# Access Compliance Report

## Public Rights-of-Way

### (Curb Ramps)

Intersection ID: 26470	Main Street: THORNBUSH_CT	Cross Street: WINTHROP_RIDGE_RD	Location: NW
ADA ID: E758E0E7CA48	Ramp Type: Perp	Initial Pass/Fail: Fail	Overall Compliance: No
		Severity Score: 12.5

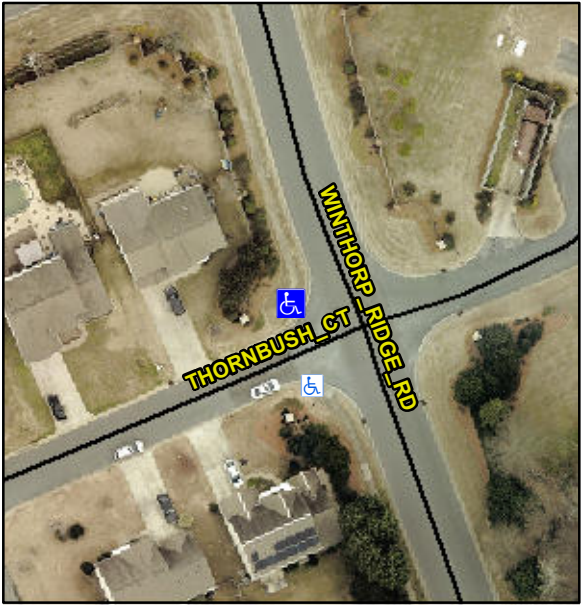
Codes/Mitigation Info/Possible Solution		Field Measurements/Component Compliance					
	Possible Solutions:						
	Remove & Replace Entire Ramp.						
	Surveyor Notes:						
	N/A						
	PROW/ADA:						
	Not Found, R304.5.3						
		Compliance	Description	Data	Compliance	Description	Data
		N/A	Ramp Length (in)	49.5	Yes	Ramp Slope (%)	6.5
		Yes	Ramp Width (in)	48.0	No	Ramp XSlope (%)	5.5
		N/A	Flare Type LT	N/A	N/A	Flare Type RT	N/A
		N/A	Flare Slope LT (%)	N/A	N/A	Flare Slope RT (%)	N/A
		N/A	Flare Traversable LT?	N/A	N/A	Flare Traversable RT?	N/A
		N/A	Landing Length (in)	N/A	N/A	DWS Provided?	N/A
		N/A	Landing Width (in)	N/A	N/A	DWS Contrast?	N/A
		N/A	Landing Slope (%)	N/A	N/A	DWS Length (in)	N/A
		N/A	Landing X Slope (%)	N/A	N/A	DWS Full Width?	N/A
		N/A	Landing Curb? (Y/N)	N/A	N/A	DWS Offset (in)	N/A
		N/A	Shared Landing?	N/A			
		N/A	Gutter Ponding?	N/A	N/A	Gutter Slope (%)	N/A
		N/A	Gutter Lip Ht (in)	N/A	N/A	Gutter X Slope (%)	N/A

N/A	Painted X Walk1?	No	N/A	Painted X Walk2?	N/A
			X Walk 1 Direction	To S		X Walk 2 Direction	N/A
		N/A	X Walk 1 Width (in)	N/A	N/A	X Walk 2 Width (in)	N/A
			X Walk 1 Slope (%)	1.7		X Walk 2 Slope (%)	N/A
			X Walk 1 X Slope (%)	2.4		X Walk 2 X Slope (%)	N/A
		N/A	Ramp inside XWalk1?	N/A	N/A	Ramp inside XWalk2?	N/A
			Road Slope (%)	N/A	N/A	Clear Space?	N/A
			Road X Slope (%)	N/A	N/A	Clear Space to XWalk (in)	N/A
		N/A	Any Obstructions?	N/A	N/A	Storm Grate/Utility Hazard?	N/A
			Obstruction Type			Storm Grate/Utility Type	
					N/A		N/A
					Yes	Surface Condition? (G/P)	Good
